bb-adc — Design Document

ai-ee v1 pipeline
generated 2026-08-19 04:58:13

learning block-basics: a single-channel analog-to-digital converter. Analog input 0-5 V DC on a screw terminal; 12-bit or better; up to 10 kSa/s; DC accuracy matters more than speed. Digital output to a host over a 0.1 inch header, which also feeds the board its 3.3 V rail. Workspace boards/bb-adc.

W1 reference headroom vs rail ripple - ACCEPTED AS ANALYSIS

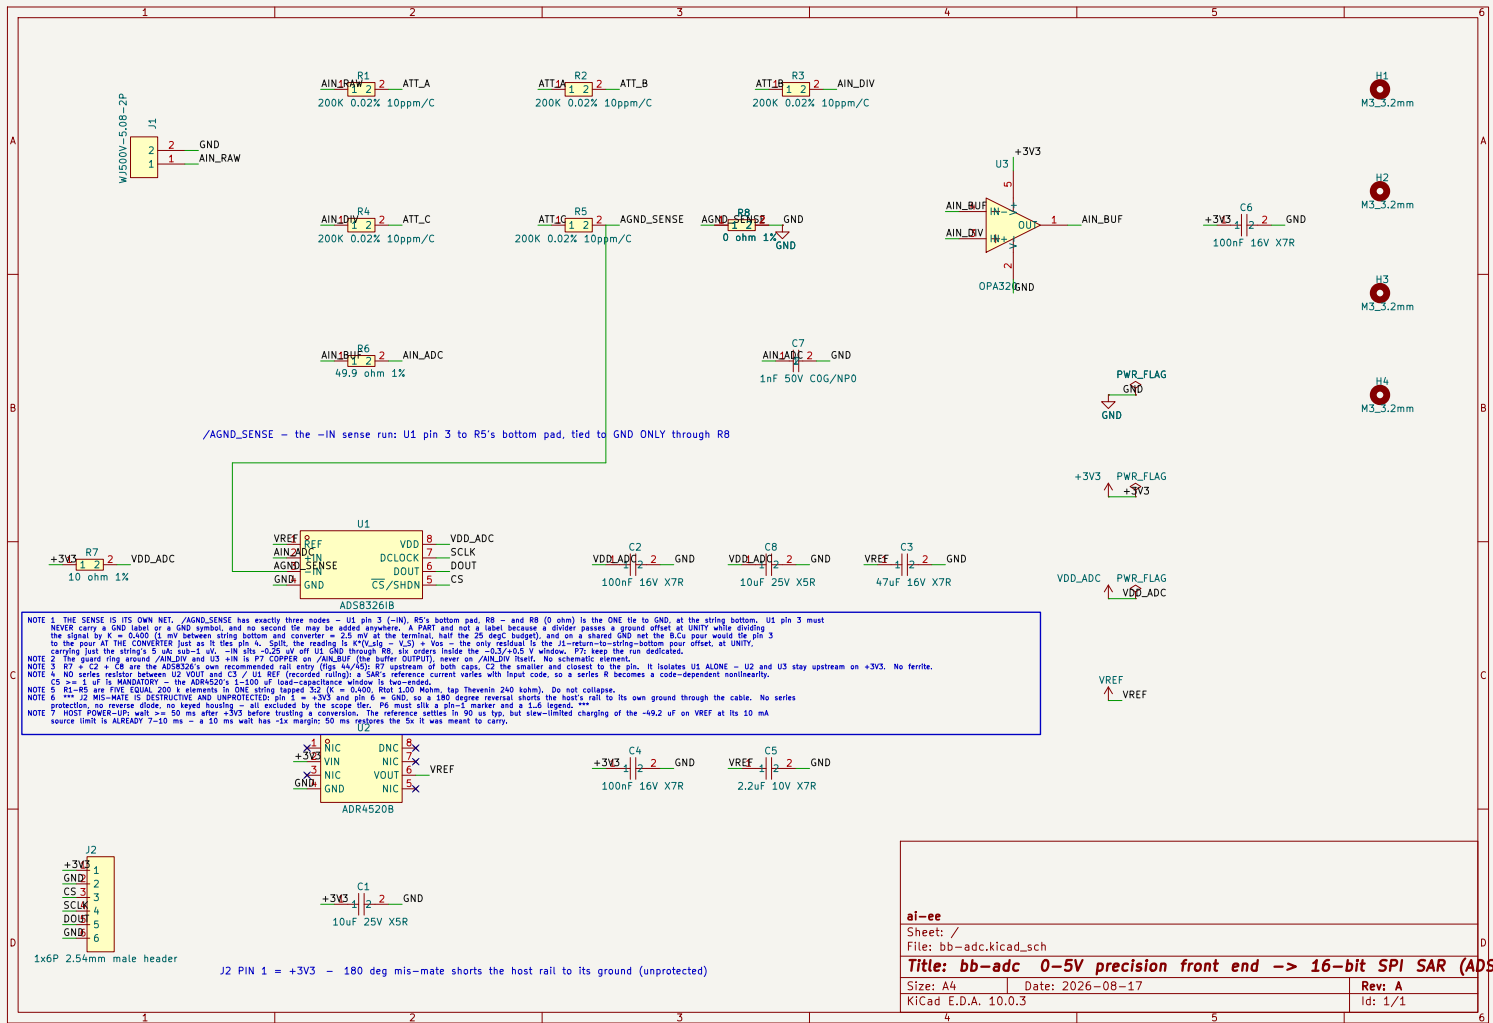
The 87 mV DC margin was compared against DC tolerance alone, while the verified record says tolerance + IR drop + ripple trough, and the owner's answered rail carries "tens of mV" of noise. Accepted because the output capacitance answers it: ~49 uF against a microamp load holds VOUT through input dips of microseconds, and a series-reference dropout spec is a DC condition. No input RC is added - the scope tier excludes filtering the datasheet does not require, and this analysis says it is not required. BINDING CONSEQUENCE, now stated: the design is validated for a host rail whose DC level stays at or above 3.135 V. Below that the margin is gone and no capacitor recovers it.
